District Five of Lexington and Richland Counties Invitation for Bid Amendment One	Solicitation #	2026-023
		Date Amendment Issued	February 20, 2026
		Procurement Official	Lauren Bové, CPPO, CPPB
		Phone	(803) 476-8182
		E-Mail Address	D5bids@lexrich5.org

DESCRIPTION	Flooring Replacement at CrossRoads Intermediate School and Dutch Fork Middle School
-------------	--

IFB# 2026-023 Flooring Replacement at CrossRoads Intermediate School and Dutch Fork Middle School
 Amendment One

AMENDMENT ONE

DUTCH FORK MIDDLE SCHOOL

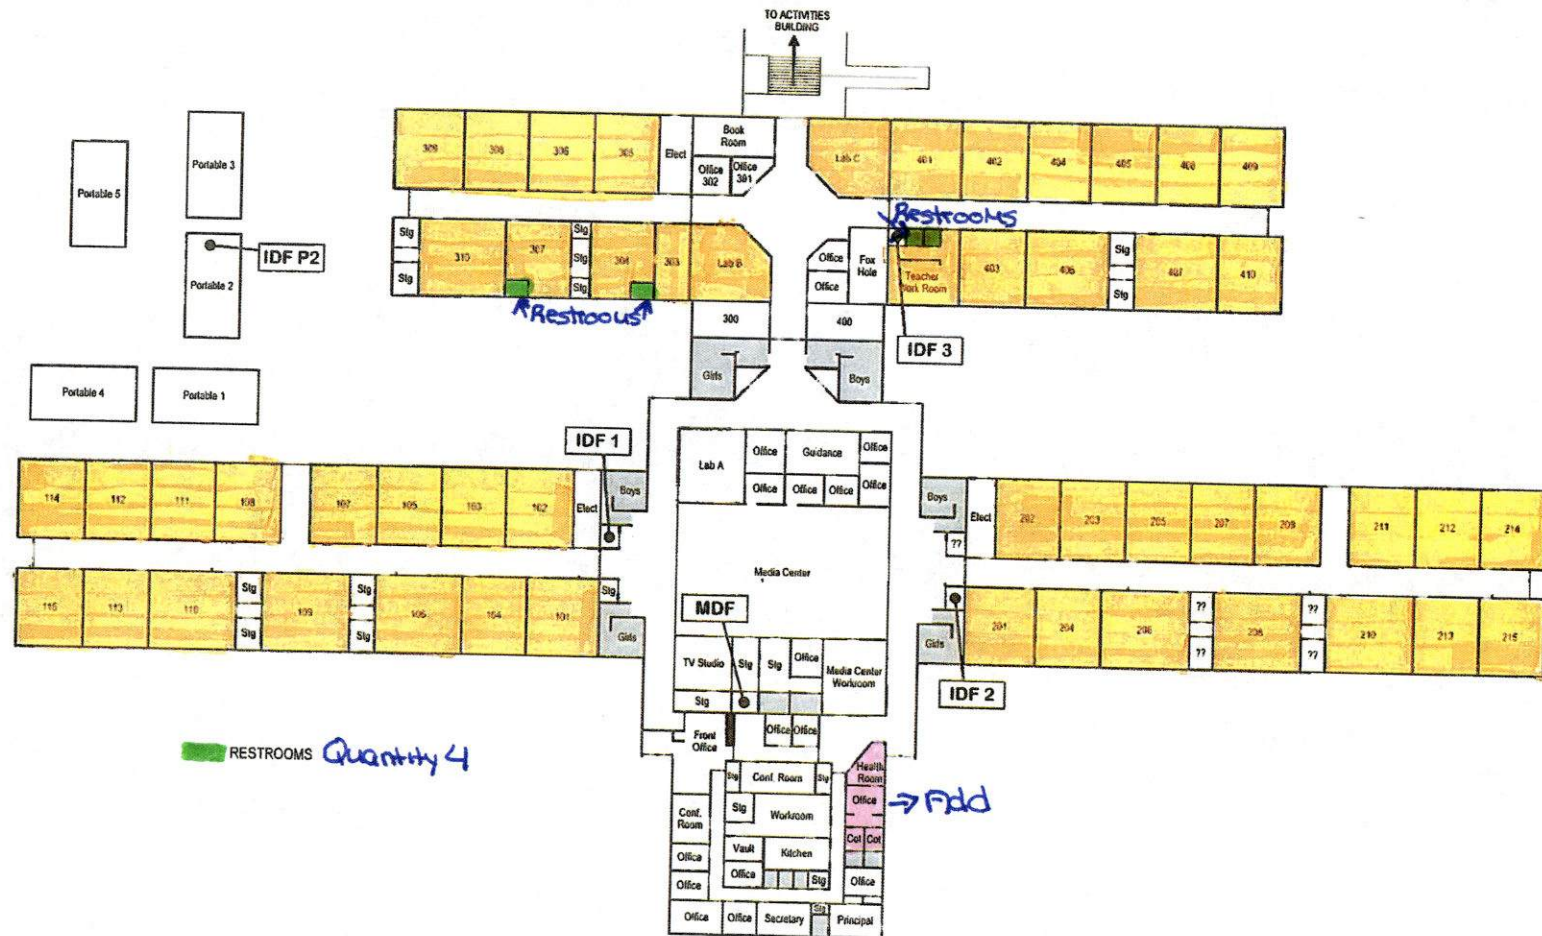
3. On page 33 of the project drawing for Dutch Fork Middle School, the health room, adjacent office and two cot areas were not highlighted. These rooms will have Texas Granite Flooring installed, please include this cost with your bid for Lot 2 (please see updated drawings herein)

4. Specification B.5 (three restrooms) is increased to a quantity of four restrooms. Two restrooms are located in the Teacher's Workroom (across the hallway from room number 401). The other two restrooms are located in room # 304 and #307 (please see updated drawings herein)

- a. Nurses Station is listed on the Bid Package for Replacement of Flooring – Is it shown on the drawings provided by the district as the Health Room and Office, but not highlighted?

- i. Measured Restrooms in Room # 304 and Room #305, - these (2) have existing VCT to be removed. Confirming these (2) are to be included in the Bid.

- ii. Measured (2) Restrooms in Teacher's Workroom Area – these have existing hard tile, does district want the hard tile to be removed before installing epoxy floor or does the district prefer installing epoxy flooring on top of the existing hard tile and base?

- iii. Also, confirming there are (4) Restrooms to be included in this Bid proposal?

- a. Per the plans there are 2 restrooms colored in the teacher's Lounge. What is the other restroom that needs to be completed? There is 2 restrooms in the Special Needs area. Is this the area that we need to address?

District's Response: On page 33 of the project drawing for Dutch Fork Middle School, the health room, adjacent office and two cot areas were not highlighted. These rooms will have Texas Granit Flooring installed, please include this cost with your bid for Lot 2

District's Response: Restrooms located in #304 and #307 are included in this bid. The contractor shall remove the exiting flooring and cove base. The contractor shall grind/blast/scrap to remove adhesive per manufacturer directions. The contractor shall provide and install a complete epoxy flooring system with integral epoxy cove base, using the Torginol Flake System with Domino FB-411 colored flakes, in accordance with manufacturers specifications. There is no restroom in #305.

District's Response: The contractor shall leave the existing hard tile in place in the two restrooms in the Teacher's Work Room area and apply the epoxy coating over the top of it.

District's Response: Specification B.5 (three restrooms) is increased to a quantity of four restrooms. Two restrooms are located in the Teacher's Workroom (across the hallway from room number 401). The other two restrooms are located in room # 304 and #307 (please see updated drawings herein)

District's Response: Specification B.5 (three restrooms) is increased to a quantity of four restrooms. Two restrooms are located in the Teacher's Workroom (across the hallway from room number 401). The other two restrooms are located in room # 304 and #307 (please see updated drawings herein)
